Development Review Division

MEMORANDUM

SUBJECT: SP21-063; Douglas 234 F6 L1 – Gas and Convenience Store
SP21-064; Douglas 234 F6 L2 - Car Wash
Review Comments 03

L1.1

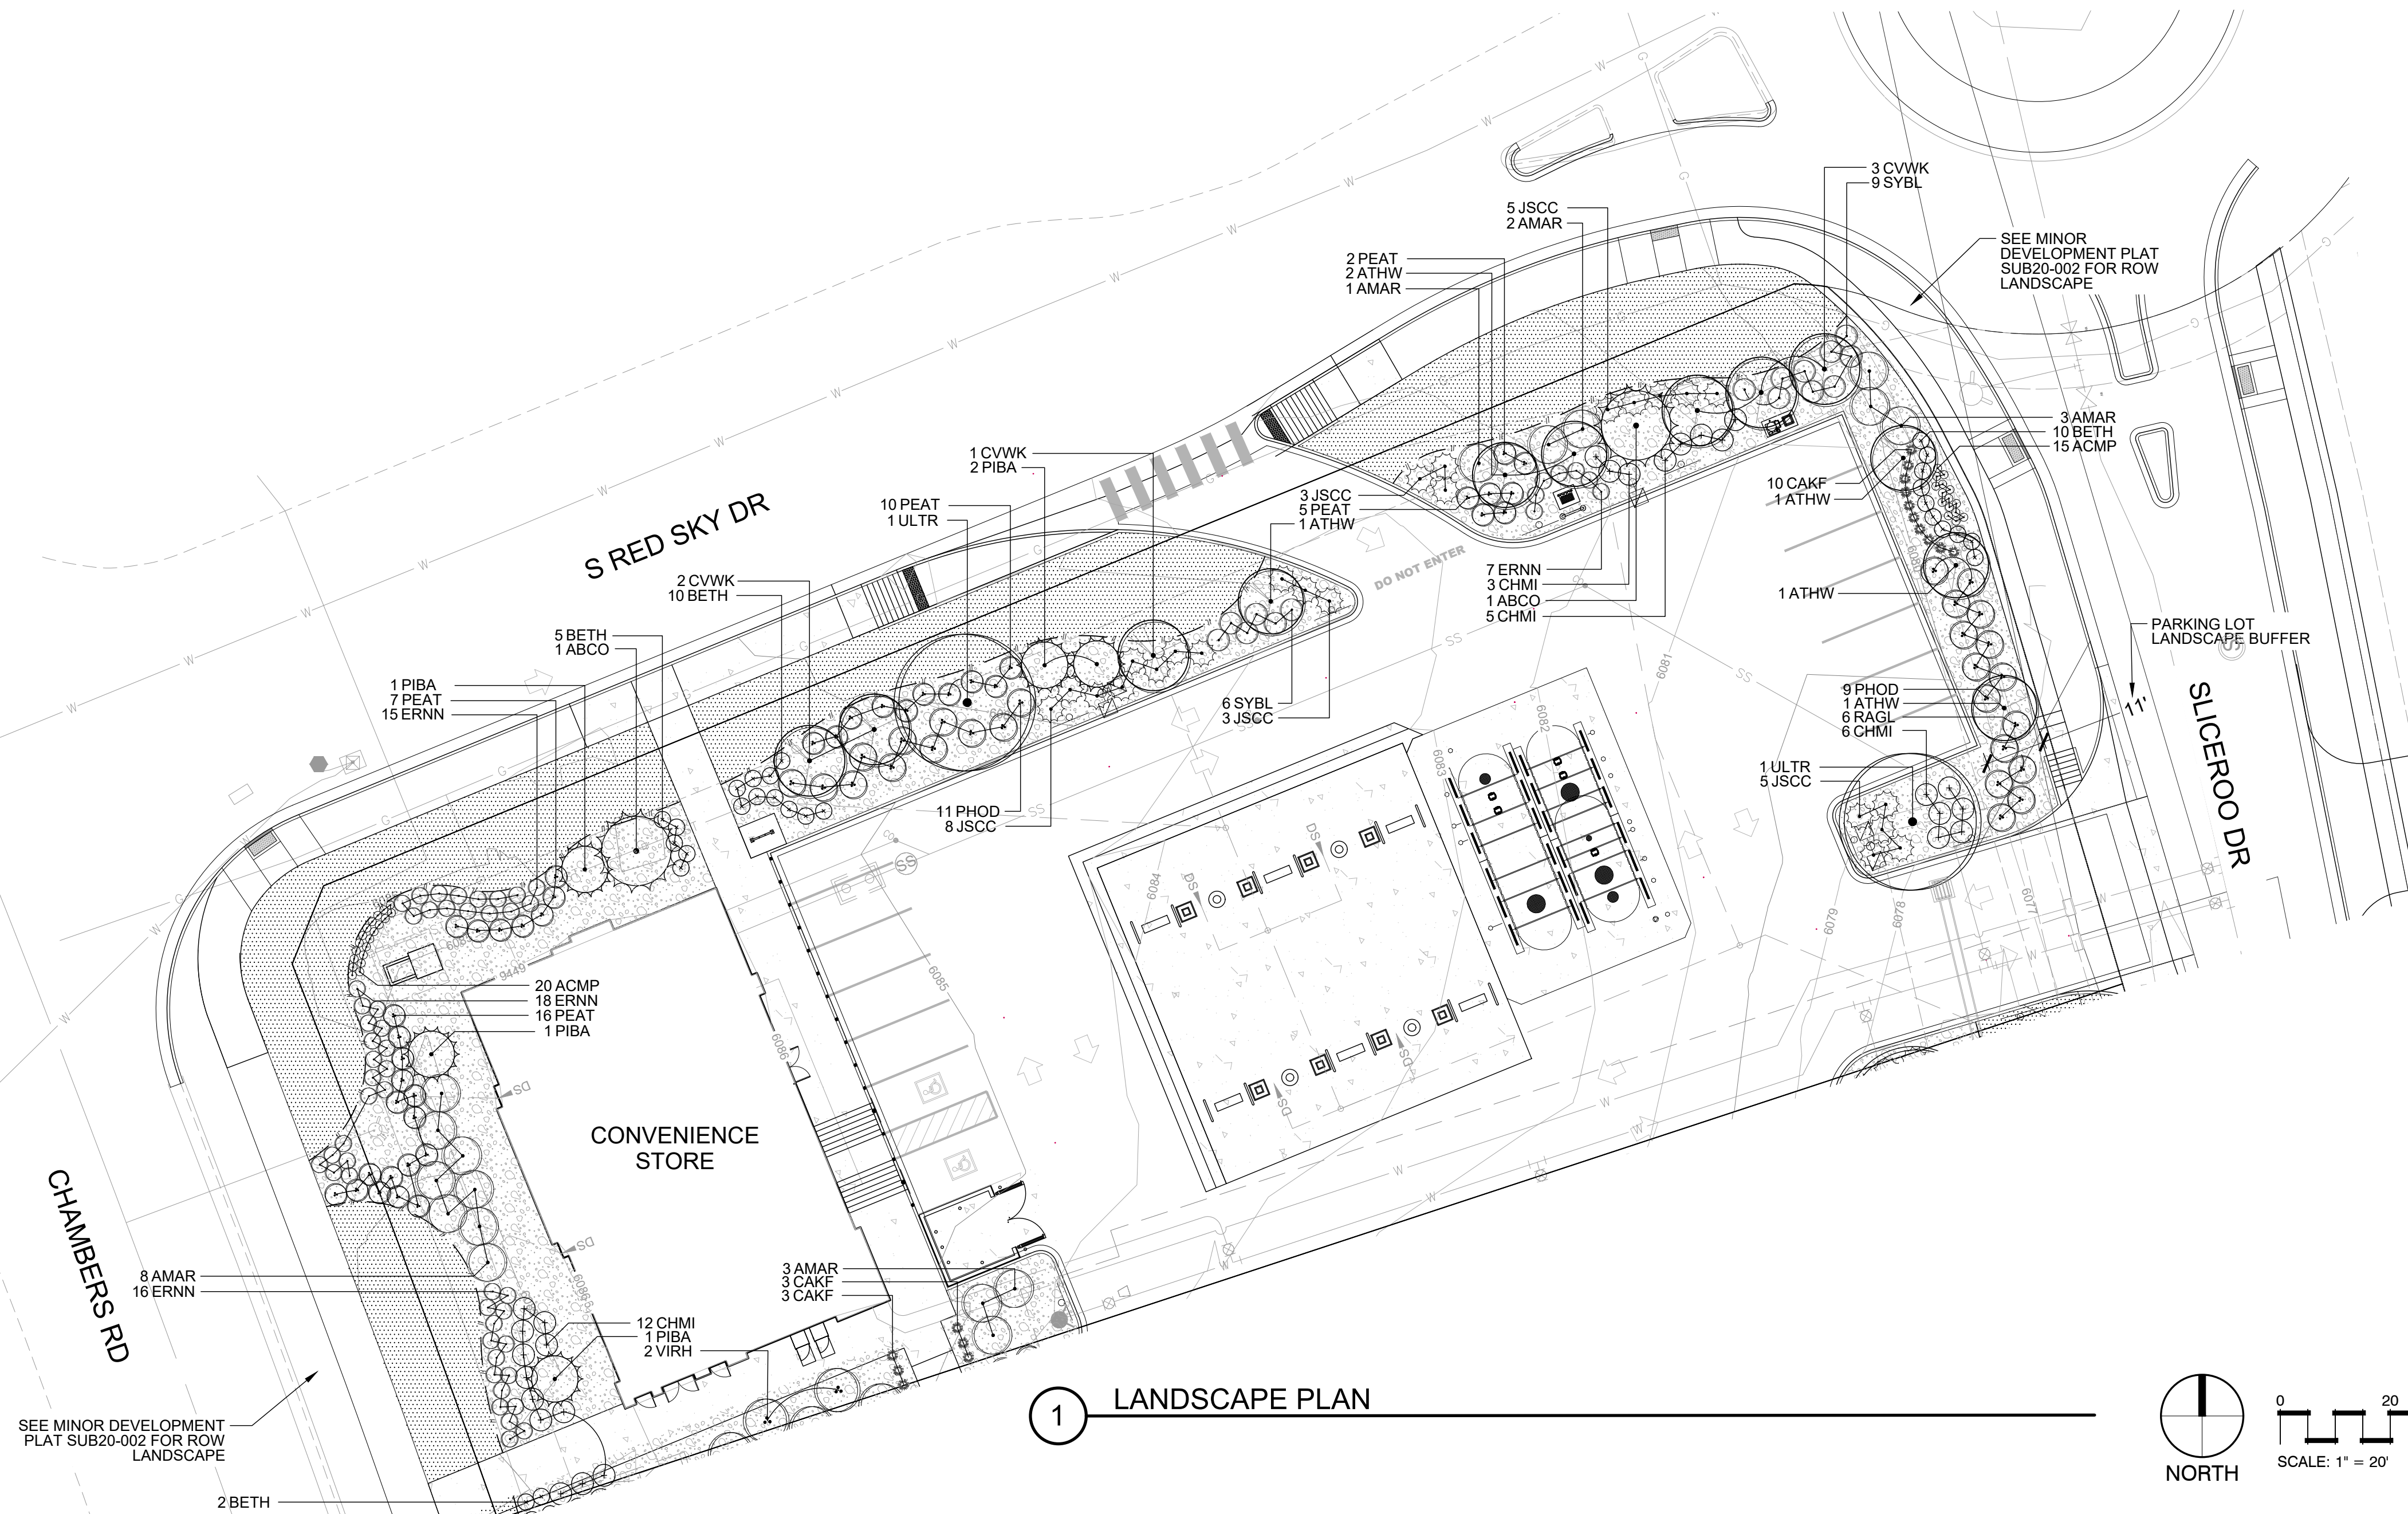
When added up, all of your shrubs in this column total 249. When I look at your plant schedule you have 233 shrubs and 16 grasses. Grasses can only be used to replace shrubs and not shrubs that are replacing trees. Also, if you are replacing shrubs with grasses its 3:1 so you would need to have 48 grasses, not 16 (you are replacing on one to one which is not allowed. You would also need to show the grass to shrub replacement in your chart. But again, these grasses cannot replace shrubs which replace trees.

L1.1

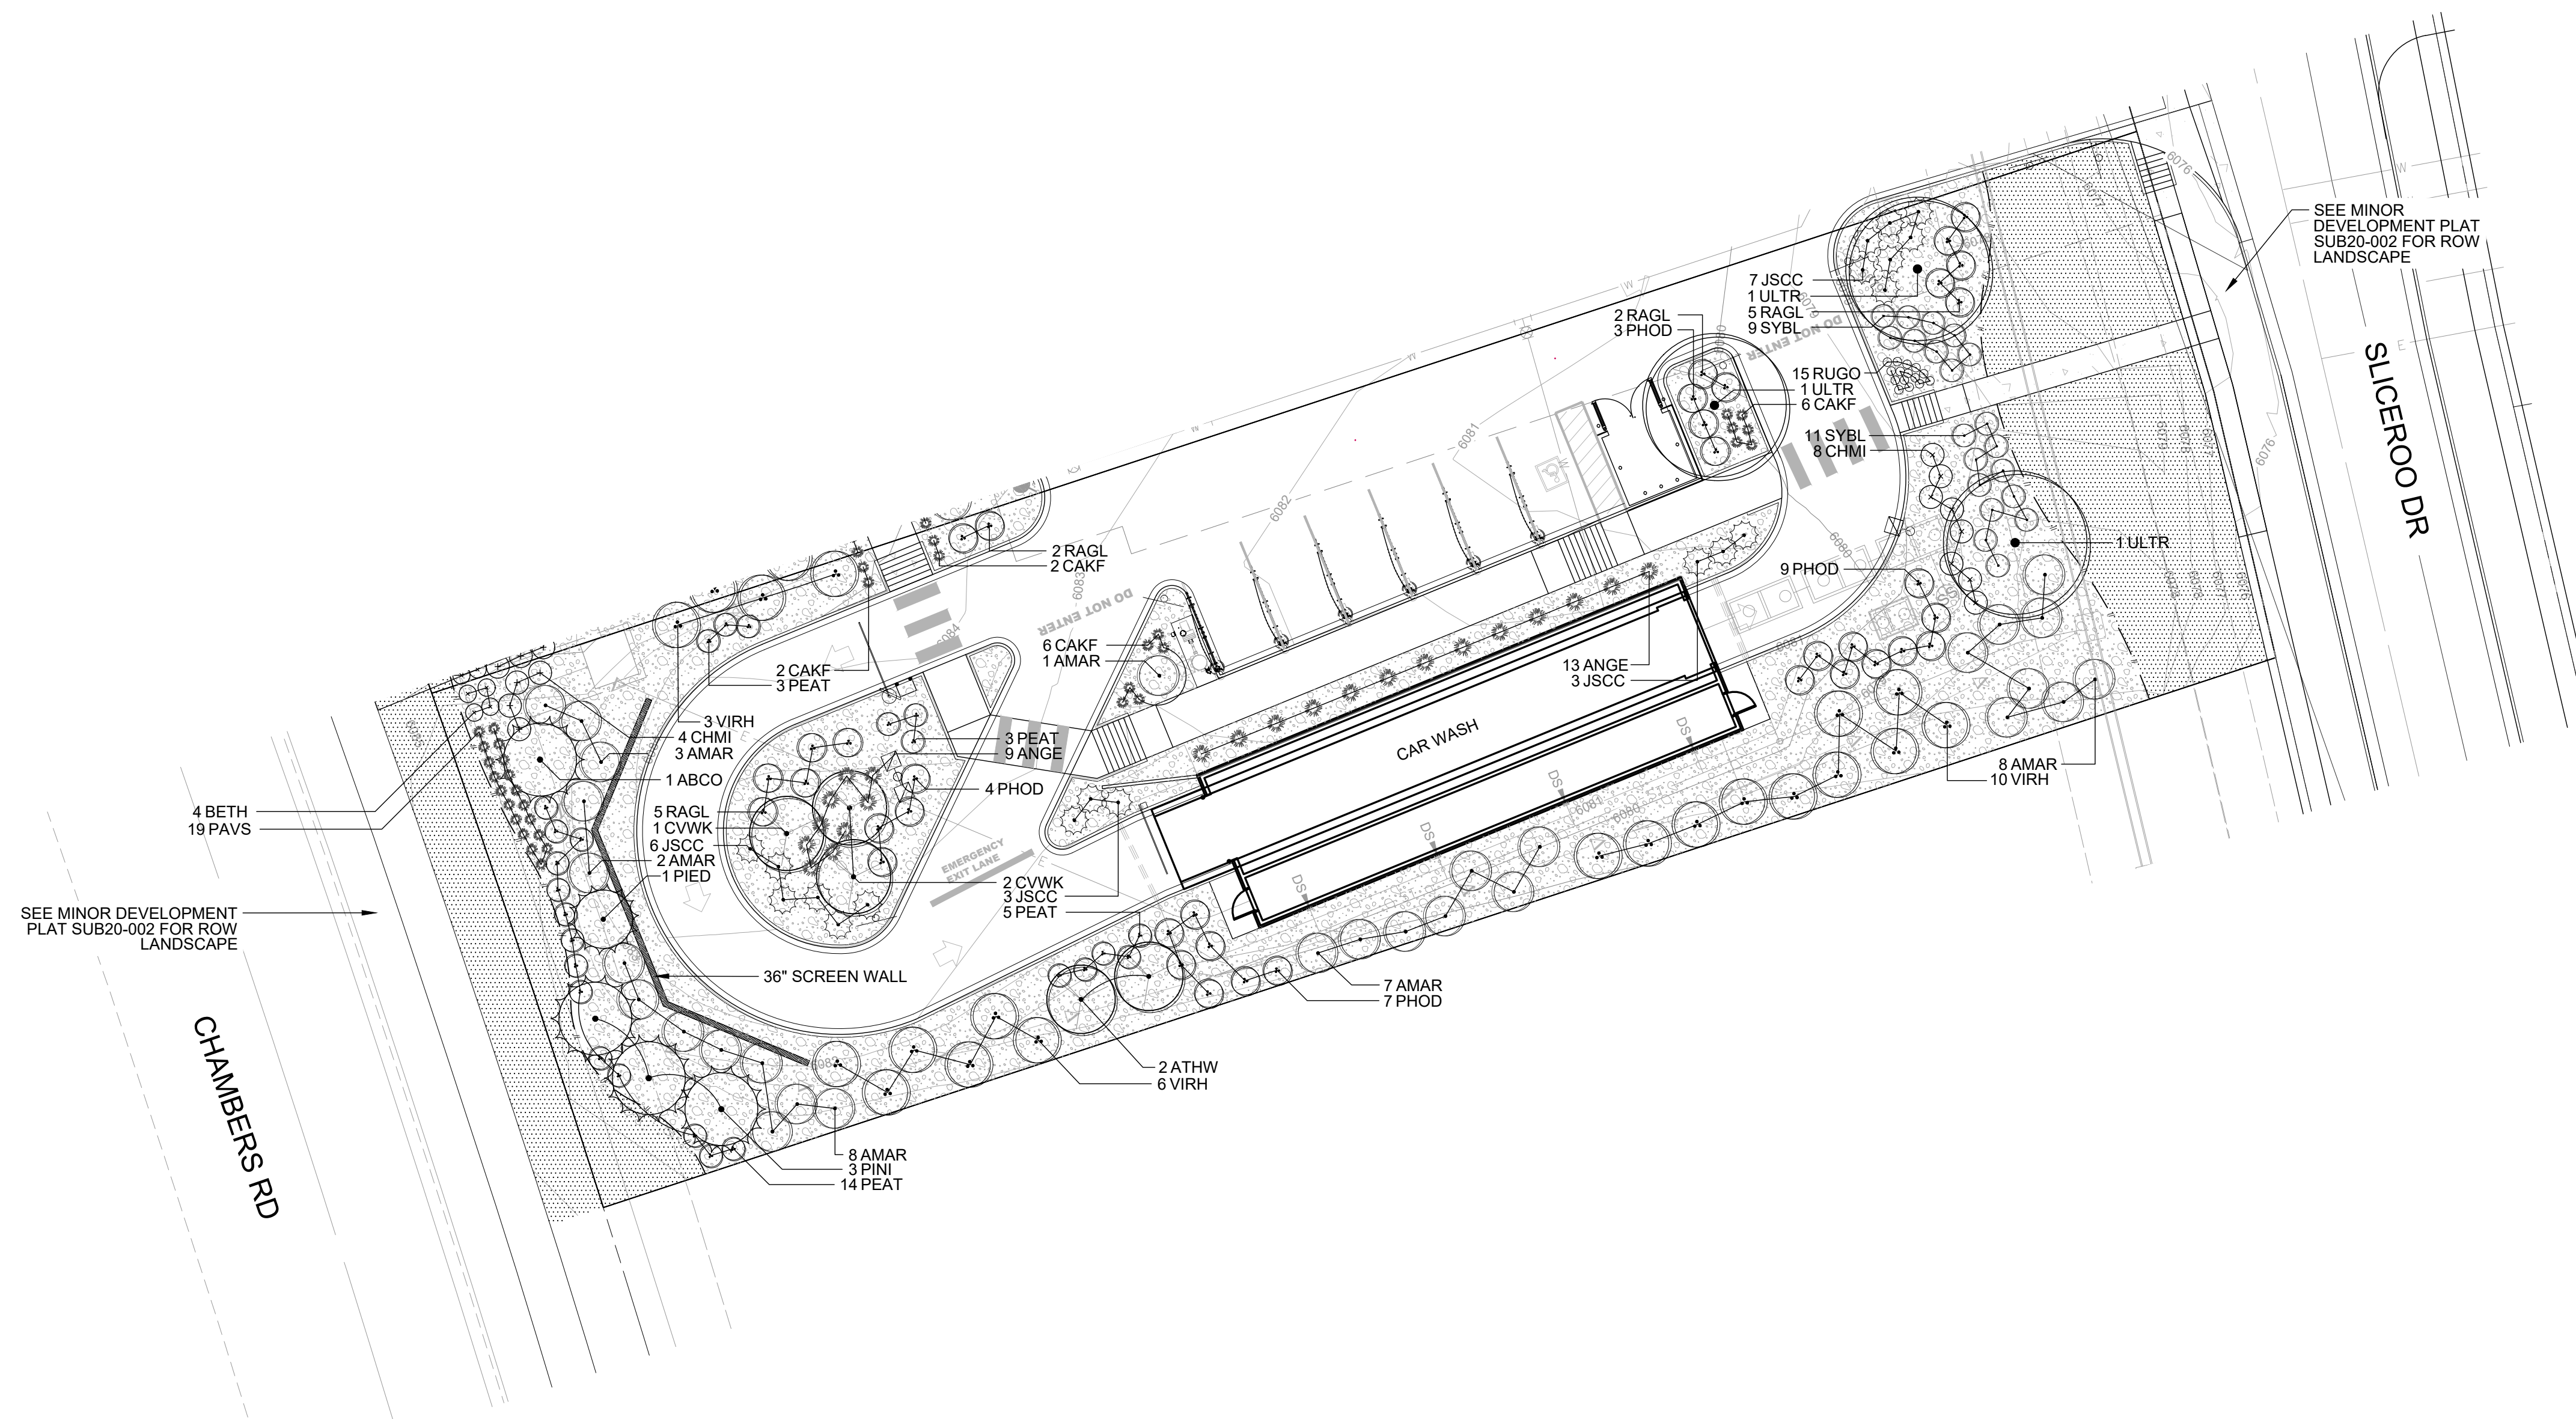
PLANT REQUIREMENT NOTES:
 1. ORNAMENTAL GRASSES AND PERENNIALS ARE COUNTED TOWARD TE'S AS 3 GRASSES = 1 SHRUB.
 When added up, all of your shrubs in this column total 189. When I look at your plant schedule you have 165 shrubs. Grasses can only be used to replace shrubs and not shrubs that are replacing trees. Also, if you are replacing shrubs with grasses its 3:1. You would also need to show the grass to shrub replacement in your chart. But again, these grasses cannot replace shrubs which replace trees.
